In the Matter of)	Docket No. 50-255
)	NRC-2021-0036
Entergy Nuclear Operations, Inc.,)	
Entergy Nuclear Palisades, LLC,)	March 29, 2021
Holtec International, and)	
Holtec Decommissioning)	
International, LLC)	
(Palisades Nuclear Plant)	
and Big Rock Point Site))	
*	*	*

Exhibit B: RESPONSE OF ROBERT ALVAREZ

Applicants’ Answer Opposing Beyond Nuclear et al.’s Petition to Intervene and Hearing Request, March 22, 2021, Page 20.

Cooling Time to **Storage** for Individual Cask Designs Allowing Preferentially Zoned Loading

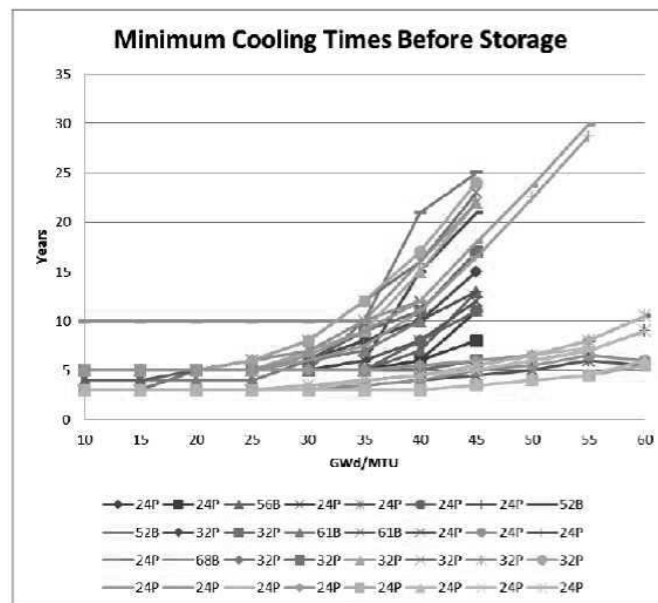
As the chart below indicates, the 2013 Sandia analysis I reference also indicates that cooling times for high burnup SNF that is preferentially loaded in to MPC (Multi-Purpose Canister) casks can be far greater than 5 years.

- Data are given for specific vendor cask designs
- The cask designs with the shortest cooling times before storage of 60 GWd/MTU fuel are all loadings of 24 PWR assemblies.
- Cooling times are not available for many designs with loadings of higher burnup fuels
